NLI-QA-3595, Rev. 1
Date 6/16/2017

SUBJECT: RESPONSE TO TWO NOTICES OF NONCONFORMANCE CONTAINED IN NUCLEAR REGULATORY
COMMISSION INSPECTION REPORT 99901471/2016-201

Statement of Nonconformance 99901471/2016-201-03

Microprocessor cycle time of Masterpact breaker with Micrologic trip unit

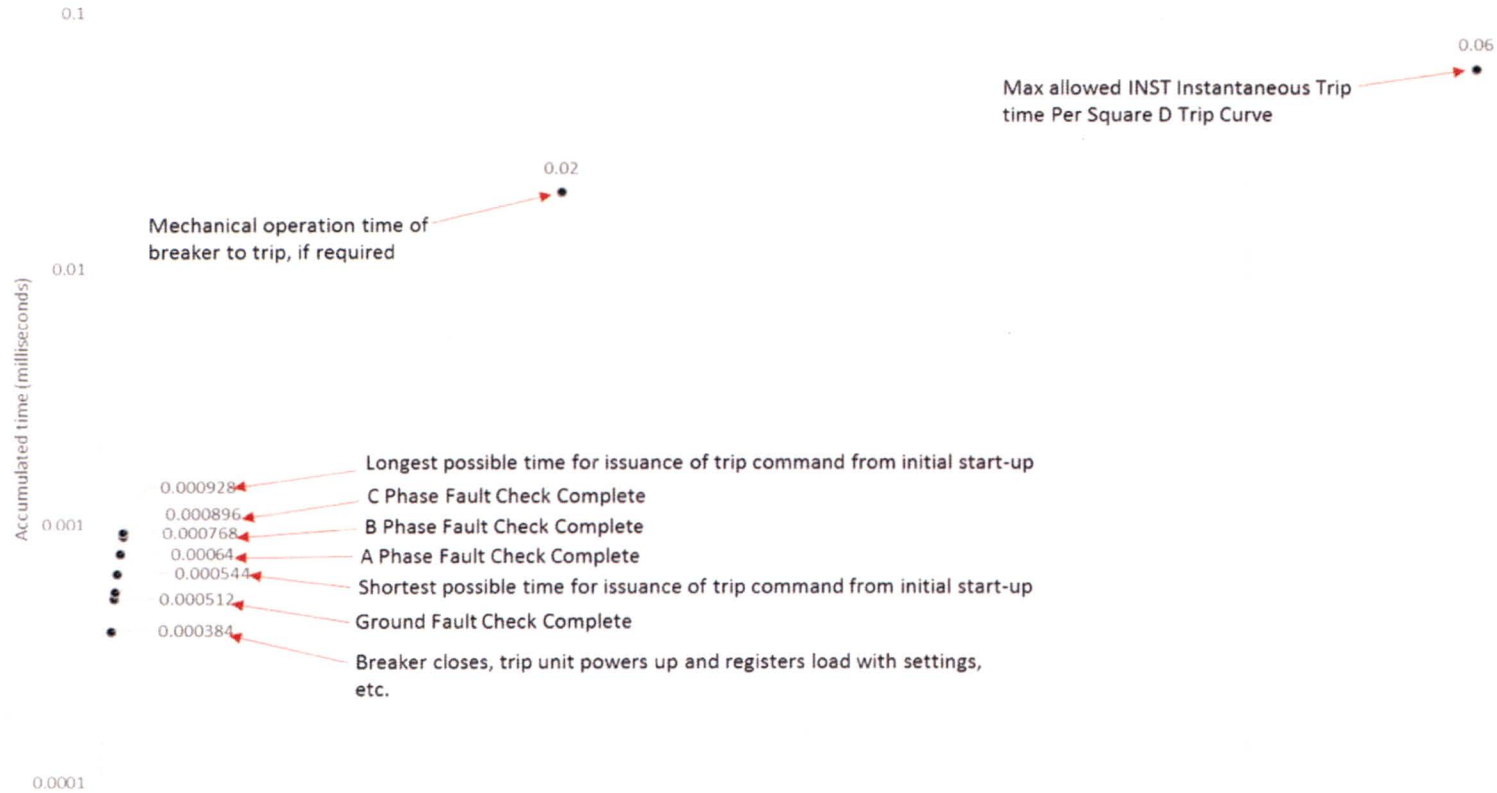
Based on the process cycle time of 544 micro-seconds, the assumption that the trip unit receives an erroneous signal and is processing the data incorrectly is not viable. After the first cycle time of 928 microseconds [0.000928 seconds] ($0.000384 + (0.000128 \times 4) + 0.000032$), the trip unit repeats the process loop every 544 micro-seconds. The nuisance trip times reported by PSEG were in the range of approximately 0.5 to 4 seconds. Therefore, if the trip unit tripped the breaker in 0.5 seconds then the process loop would have been repeated approximately 920 times, which would indicate that the trip unit was operating properly after the initial startup.

After the trip command is issued, the mechanical operation of the breaker to move from the closed to the fully open position is approximately 20 milliseconds. From the issuance of a signal to trip, the total time for tripping the breaker is less than 25 milliseconds. Based on the information provided above regarding the start-up time of the trip unit, if the trip was caused by the processor being confused, the nuisance trip would have occurred within the first 25 milliseconds of operation. Due to the fact that the trips were anywhere from 0.5 to 4 seconds (as reported by PSEG) it is concluded that the trips were not as a result of the startup time of the trip unit.

Figure 1 below illustrates the timing of the trip unit and breaker.

Note: The above plot shows the time required for a trip unit start-up from no power to issuance of a trip command. After the initial start-up time of 384 micro seconds (0.000384 sec), the trip unit runs through the process loop every 512 micro seconds (0.000512 seconds) checking the breaker for faults.
